**Re: Remediation Work Plan
Peaches 19 Fed No. 1 Battery
Incident Number: nAPP2515629079
Eddy County, New Mexico**

Operator: CHEVRON U S A INC 6301 Deauville Blvd Midland, TX 79706	OGRID: 4323
	Action Number: 530967
	Action Type: [C-141] Site Char./Remediation Plan C-141 (C-141-v-Plan)

Proposed Excavation Extent

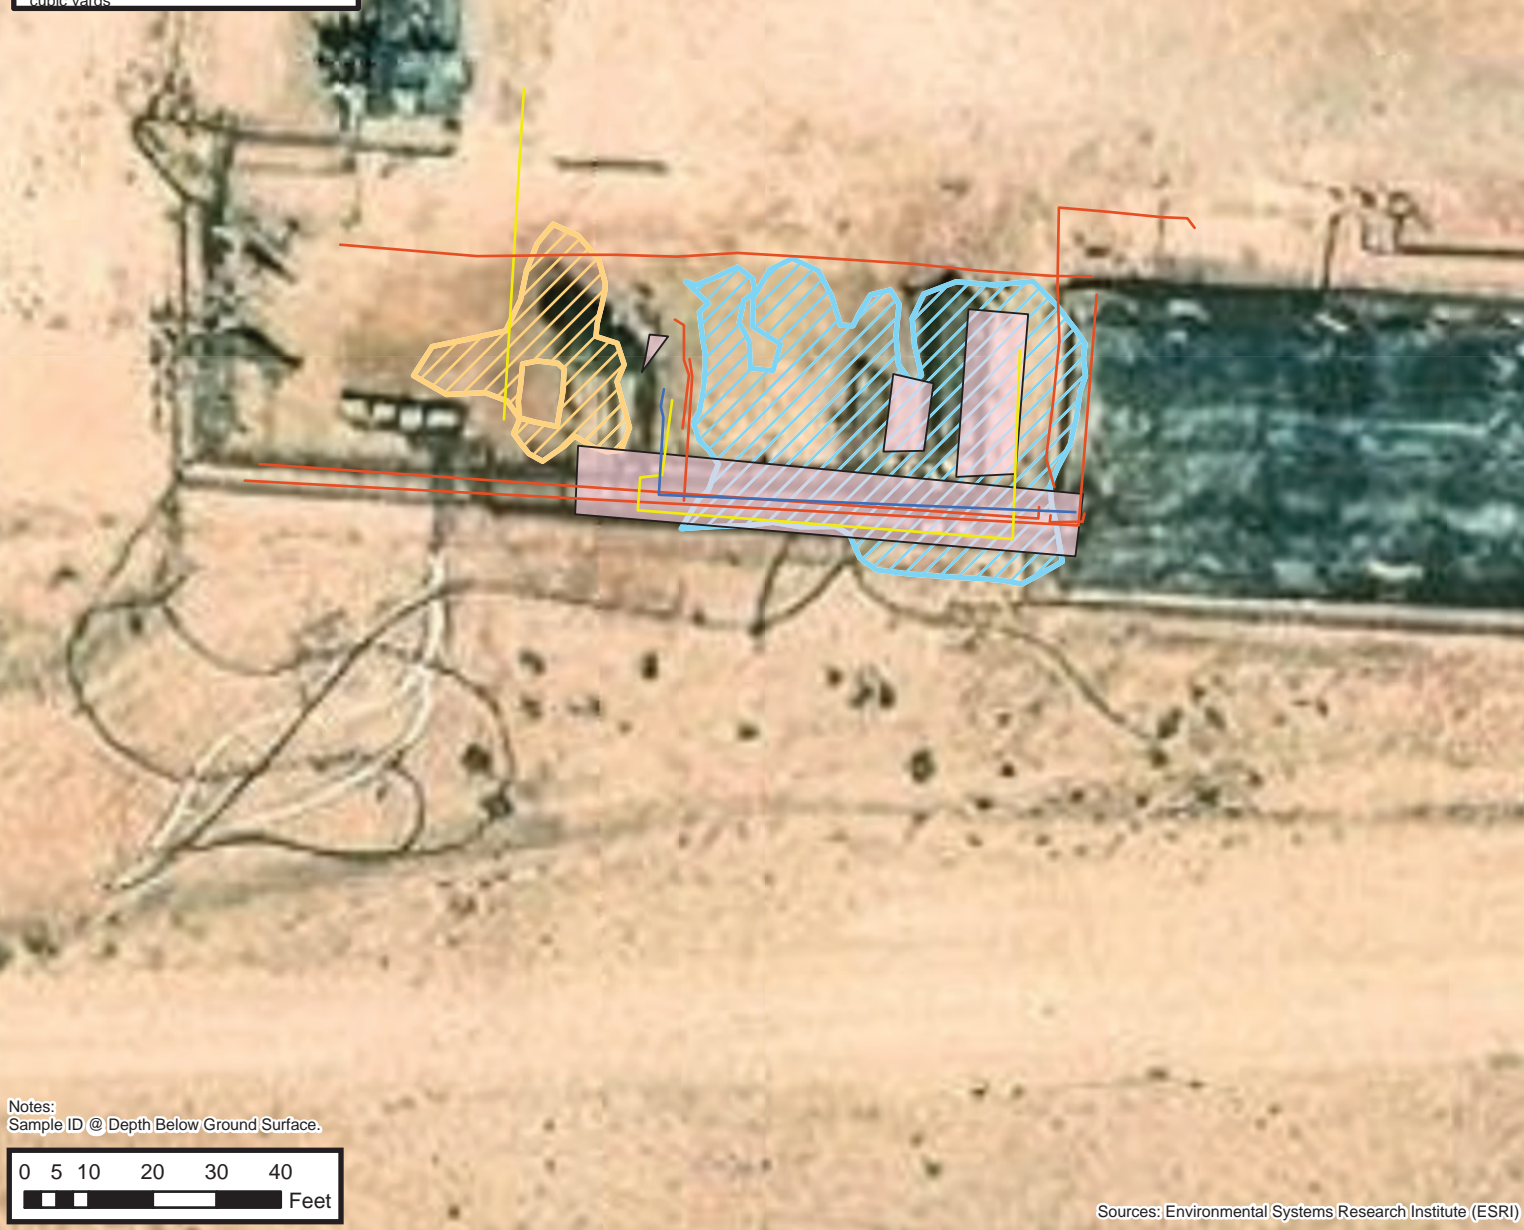
Created By	Condition	Condition Date
scwells	Remediation plan approved with the following conditions: Since this release is resulting in two separate excavation areas OCD would also like to see a 5 point confirmation sample collected at surface between the excavation areas to confirm no surficial contamination remains here since BH04 at surface had 174,000mg/kg of chloride. A remediation closure report is due to the OCD by 3/9/2026.	12/9/2025
